Norfolk Boreas Offshore Wind Farm (EN010087)

Statement of Common Ground

Applicant: Norfolk Boreas Limited
Document Reference: ExA.SoCG-8.D9.V2
Deadline 9

Project:	Highways England Spatial Planning Arrangement 2016-2020	Job No:	60506522 / DN053.002
Subject:	Norfolk Boreas Offshore Wind Farm – EIA Traffic & Transport Method Statement Review		
Prepared by:	Kelly Davis	Date:	16th February 2018
Checked by:	Andrew Cuthbert	Date:	21st February 2018
Verified by:	Liz Judson	Date:	22nd February 2018
Approved by:	Andrew Cuthbert	Date:	22nd February 2018

DRAWN	JJ	CHECKED	RNE	APPROVED	ADR
DATE	11.02.19	SCALE AT A1	1:500 up to	CLIENTS REF.	
DRAWING No.	TP-PB4476-DR025	REVISION			
CLIENT DWG No.					D0.1

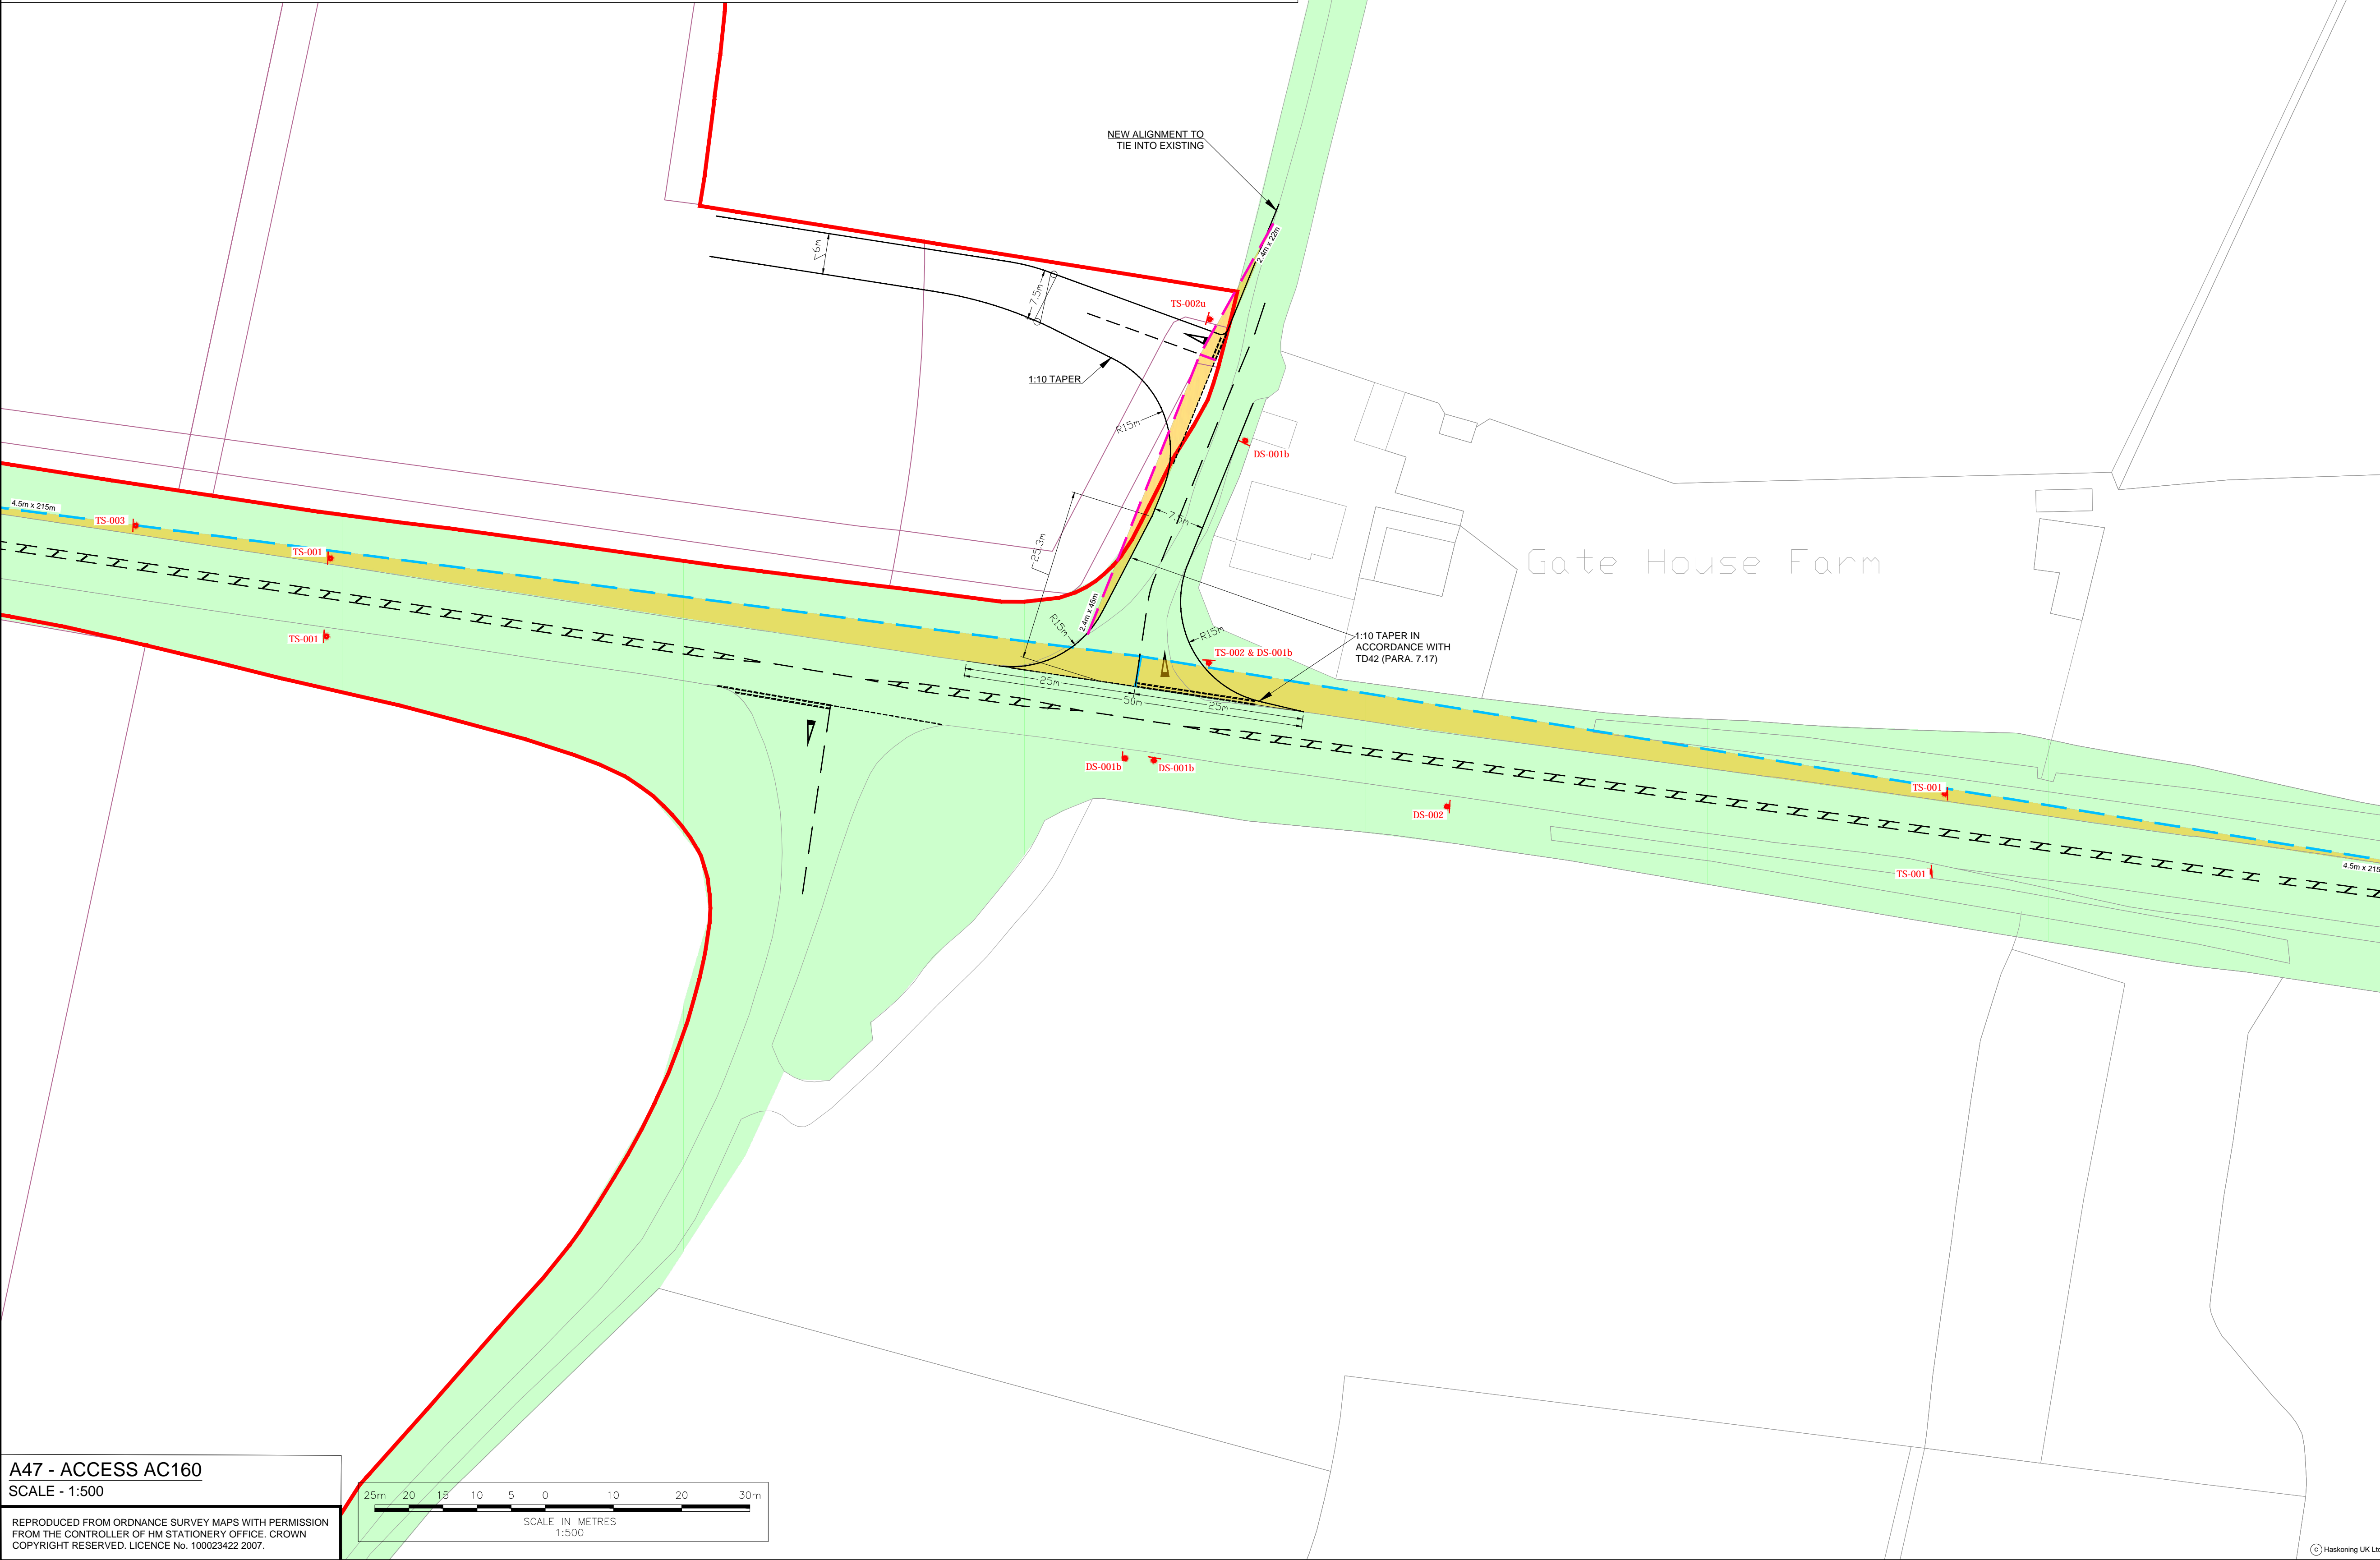
15. The layout of site access junction AC160 illustrated on Drawing PB4476-DR025 D0.1 appears to provide satisfactory geometry to accommodate heavy vehicles turning to and from the A47. There is no suggestion that the use of this junction by vehicles accessing the works would give rise to a queue of stationary traffic within Bushy Common Road waiting to enter the site, such as would risk generating a queue of traffic back to the A47, some 50m away.

19. The layout of the improved junction between the A47 and Bushy Common Road, illustrated on Drawing PB4476-DR025 D0.1, appears to provide in full for the requirements of DMRB Design Standard TD42 for this type of junction. In addition, the swept path plots shown on Drawings PB4476-DR026 and 027 show that it can accommodate heavy vehicles turning on and off the A47 without clipping kerb lines, and without encroaching on the wrong side of the A47 or the minor road.
